Planning and Zoning Commission- Regular Meeting AGENDA

Monday, June 08, 2020 at 5:30 PM
Ketchum City Hall
480 East Avenue North, Ketchum, ID 83340

- 8. ACTION - 4th & Main St Mixed-Use Building Pre-Application Design Review:** Main Street between 4th and 5th Streets (Ketchum Townsite: Block 5: Lots 1, 2, 3, and 4.) The Commission will consider and give direction on a Pre-Application Design Review submitted by Chris Ensign of Solstice Homes Development for a new four-story, 47.5 foot tall, 59,130-square-foot mixed-use building located on four lots on Main Street between 4th and 5th Streets within the Retail core of the Community Core (CC-1). *Continued from March 9, 2020.*

Project Plans with Updates

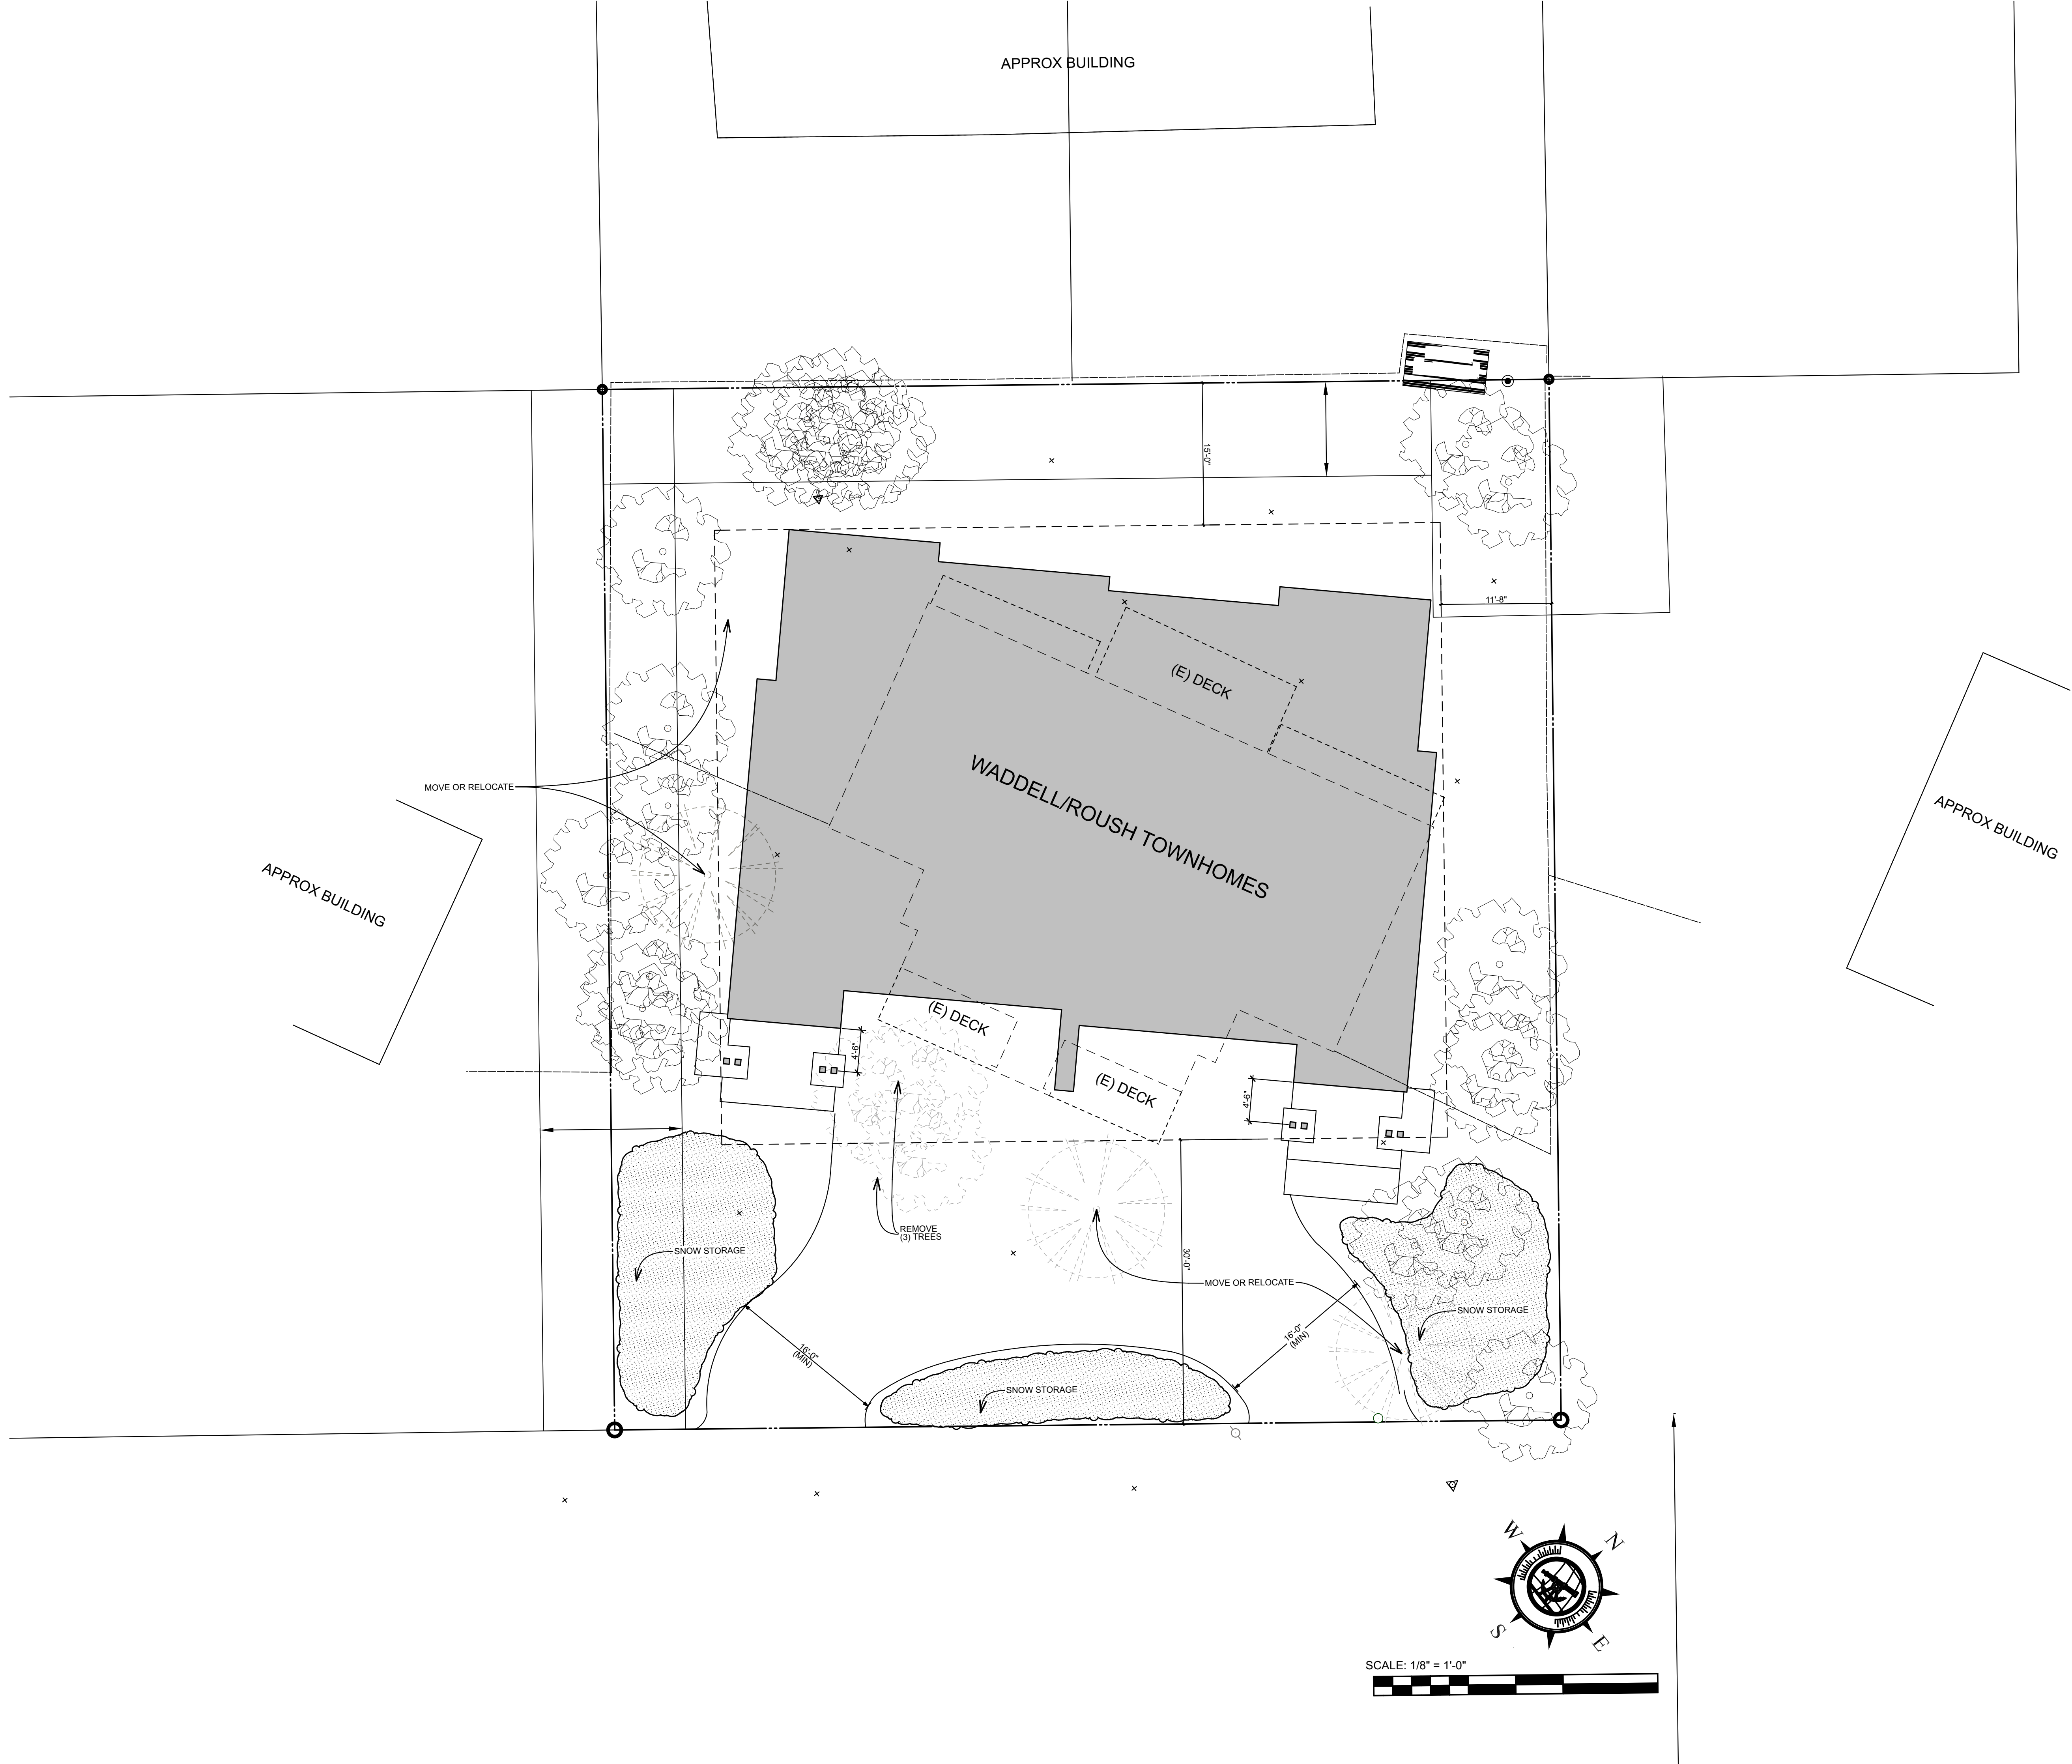
The updated landscape plan is indicated on Sheet L-01 of the project plans (Exhibit B). Three new fir trees have been added to the backyard. These coniferous trees will help soften the rectangular building mass and provide visual relief at the rear elevation. Aspen trees have been added to the side yards. The island separating the two circular driveway entrances has been enhanced with new landscape plantings. The introduction of new trees and shrubs enhances screening between neighboring properties and Warm Springs Road.
